ACCESSION NBR: 8707010205 DOC. DATE: 87/06/25 NOTARIZED: NO DOCKET #  
 FACIL: 50-315 Donald C. Cook Nuclear Power Plant, Unit 1, Indiana & 05000315  
 50-316 Donald C. Cook Nuclear Power Plant, Unit 2, Indiana & 05000316  
 AUTH. NAME AUTHOR AFFILIATION  
 ALEXICH, M. P. Indiana & Michigan Electric Co.  
 RECIP. NAME RECIPIENT AFFILIATION  
 Document Control Branch (Document Control Desk)

SUBJECT: Provides addl response to NRC 860924 ltr requesting  
 schedules for addressing plant-specific design features of  
 ATWS mitigation sys actuation circuitry. Requests preliminary  
 indication of acceptability of util program by 870801.

Donald C. Cook Nuclear Plant Unit Nos. 1 and 2  
Docket Nos. 50-315 and 50-316  
License Nos. DPR-58 and DPR-74  
GENERIC LETTER 83-28, 10 CFR 50.62, AMSAC

AMSAC ISOLATION DEVICE--REQUEST FOR ADDITIONAL INFORMATION

Figure 1

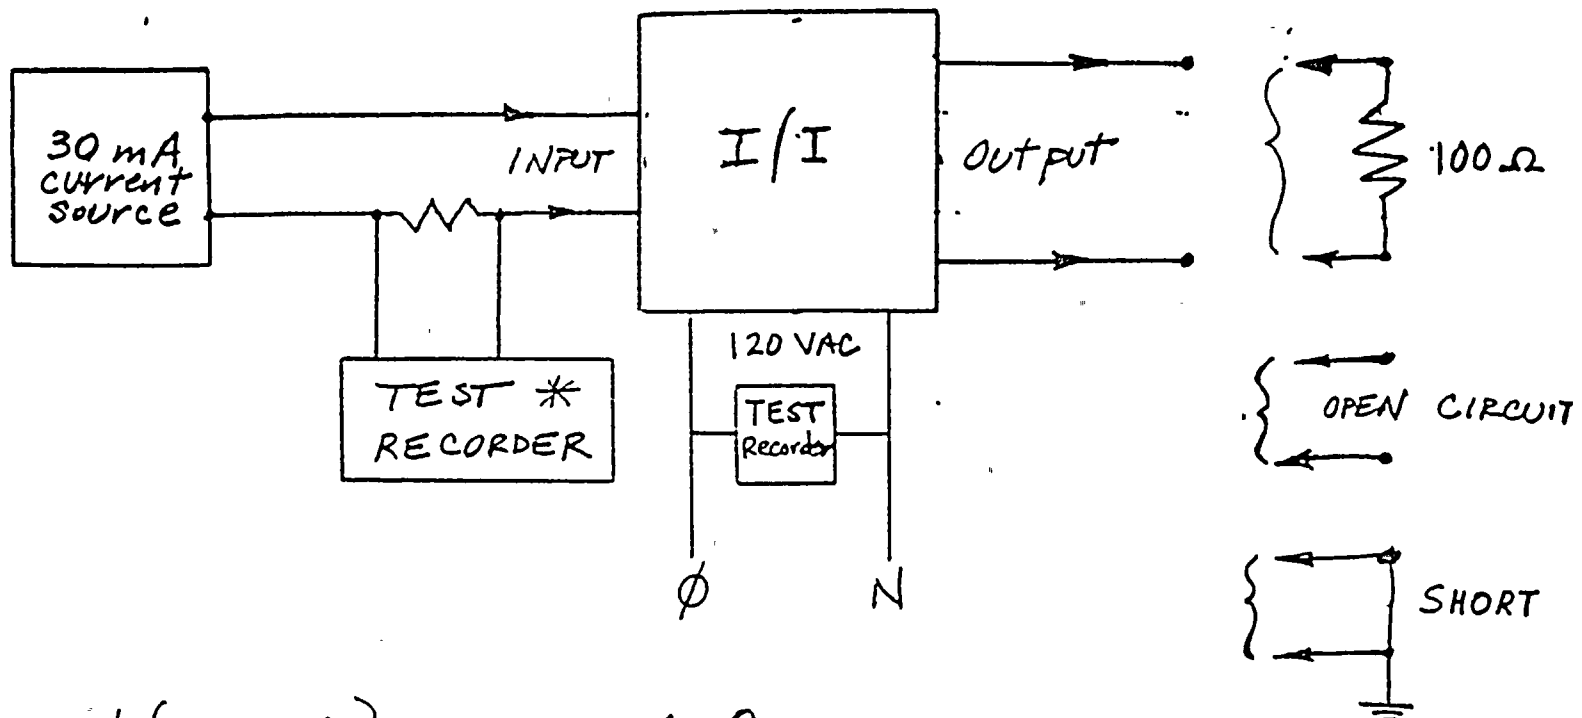
- c. Data to verify that the maximum credible fault was applied to the output of the device in the transverse mode (between signal and return) and other faults were considered (i.e., open and short circuits).

- 1). a nominal 100 ohm normal resistive load.
- 2). an output circuit open.
- 3). an output circuit short.
- 4). a nominal 110v AC, but not greater than a nominal 220v AC, voltage applied to both between the output leads and between both leads and ground.
- 5). a nominal 128v DC, but not greater than a nominal 250v DC, voltage applied to both between the output leads and between both leads and ground.

Response: Figure 1 indicates that the maximum credible faults will be applied to the output of the I/I in the transverse mode. Other possible faults (open and short circuits) are also depicted.

**SUBJECT** AnsAC - Figure #1

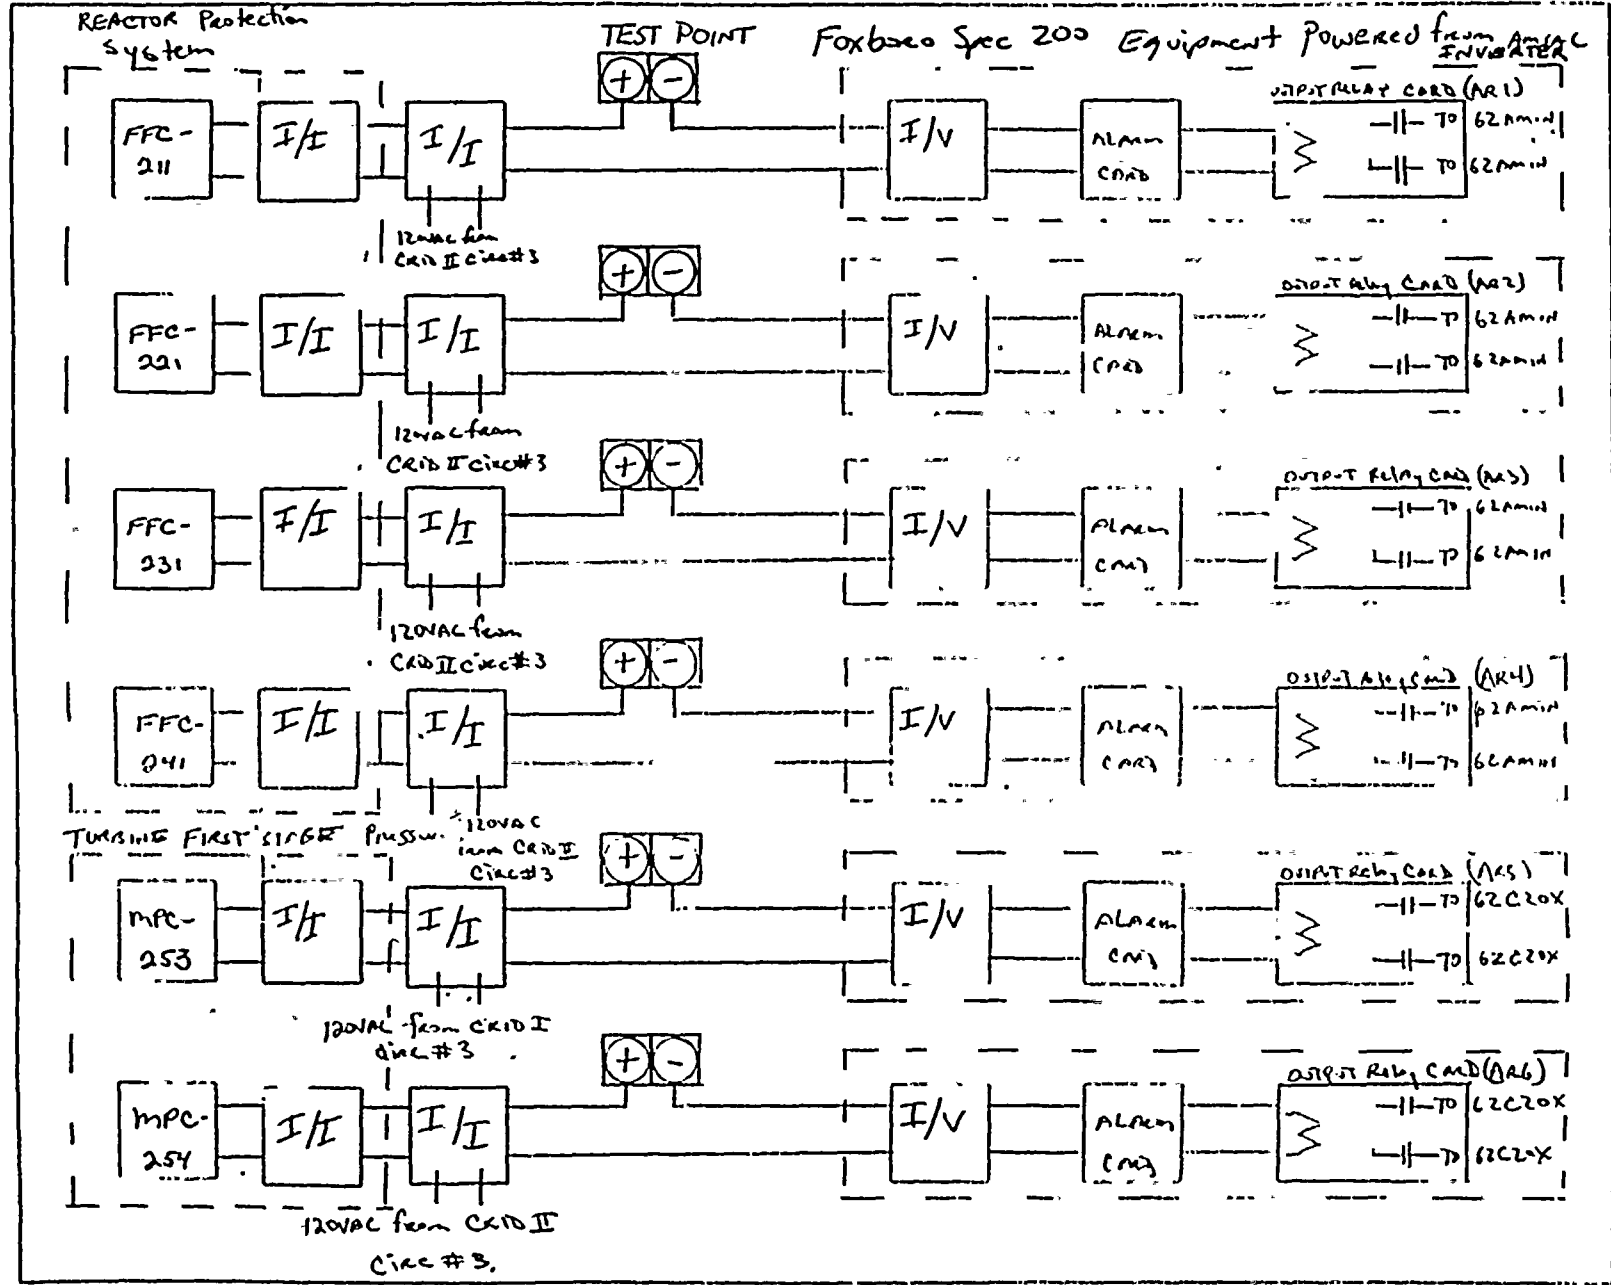
This preliminary AMSAC design package is being submitted to give the NRC an opportunity to comment on the concept and circuitry to the extent that it has been finalized. A final design package will be submitted in the final quarter of 1987 which will provide the following additional information:

Figure #1 shows the signal sensing block diagrams. We will sense feedwater flow from the existing flow transmitters (FFC-211, 221, 231, 241). The AMSAC power permissive signal will be sensed from the existing turbine 1st stage pressure transmitters (MPC-253, 254). We are adding new current repeaters (I/I) to each sensing loop. For the feed flow sensing loops, we will be placing the I/I's in the RPS cabinets and powering them from the existing power supplies: The Control Room Instrumentation Distribution System (CRIDS). These 120V ac supplies are powered from the existing station batteries via Class 1E inverters. Test points are available to inject signals for testing, trouble shooting, and maintenance. The logic equipment is the Foxboro Spec. 200. It will be powered from the AMSAC inverter and will be housed in the AMSAC cabinet which will be located in the control room.
